From: [ANDERSON, Victoria](#)
To: [Frumkin, Daniel](#)
Subject: [External_Sender] Proposed revision to FAQ 59 (Monitoring)
Date: Friday, April 22, 2016 1:40:03 PM
Attachments: [FAQ-10-0059-Rev-6-Monitoring.docx](#)

FAQ Title NFPA 805 Monitoring

Plant:	Harris Nuclear Plant	Date:	February 10, 2012
Contact:	Joelle DeJoseph/ Dave Miskiewicz	Phone:	919-546-6247
		Email:	joelle.dejoseph@pgnmail.com

Figure E-1 – NFPA 805 Monitoring Process

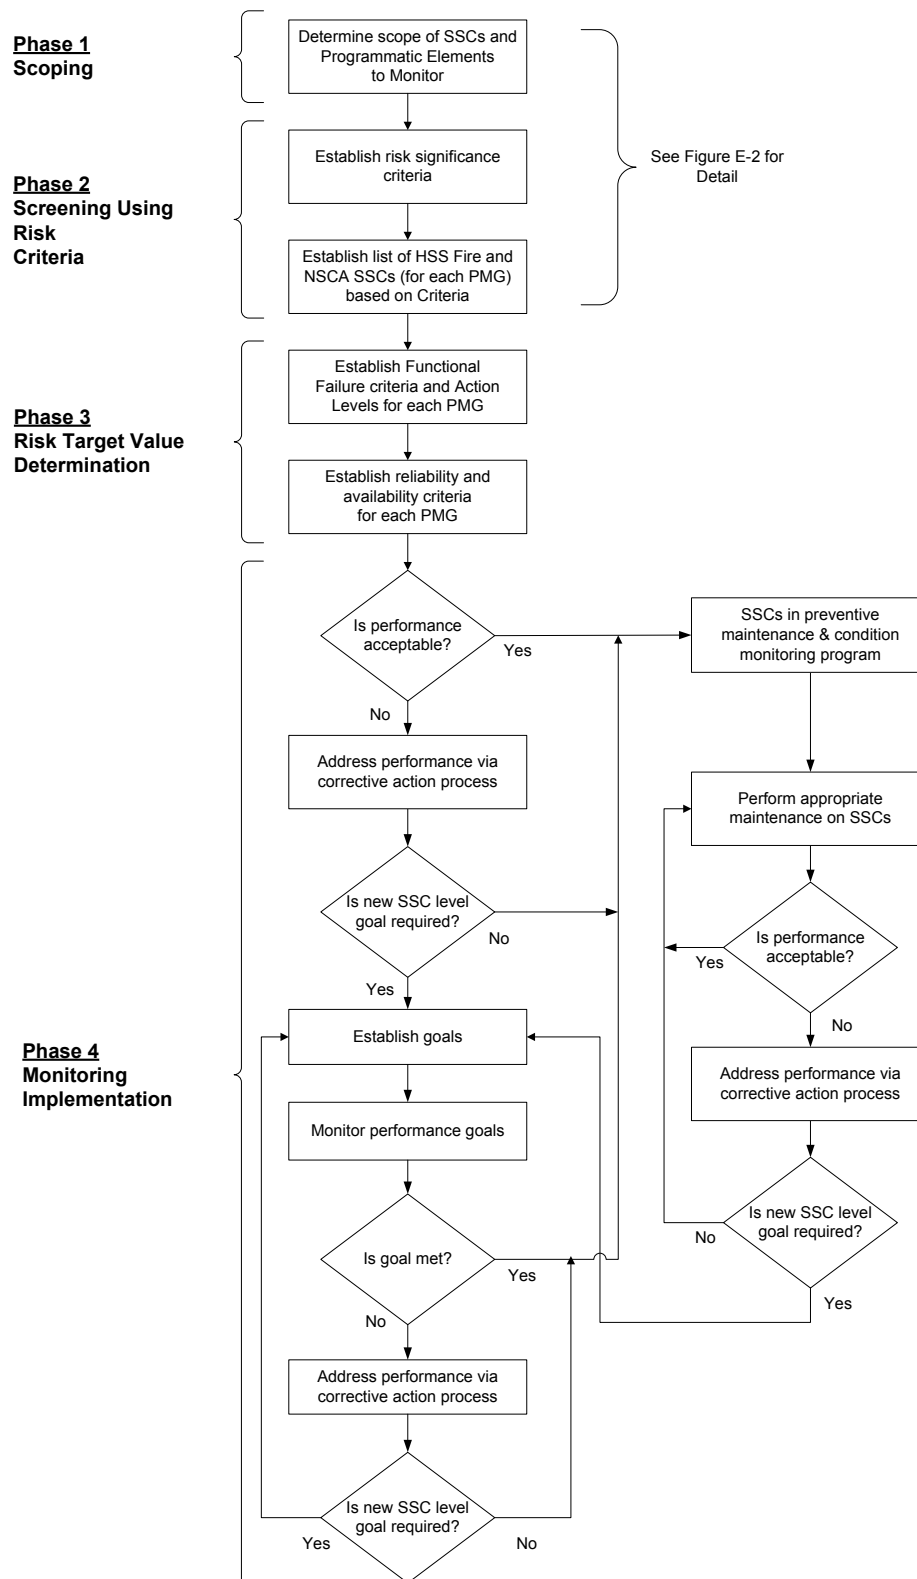
REPLACE ALL OF APPENDIX E WITH THE FOLLOWING:

A suggested methodology is outlined below. Figure E-1 provides an overview of the Monitoring Process, while Figure E-2 provides detail on a process for Phases 1 and 2.
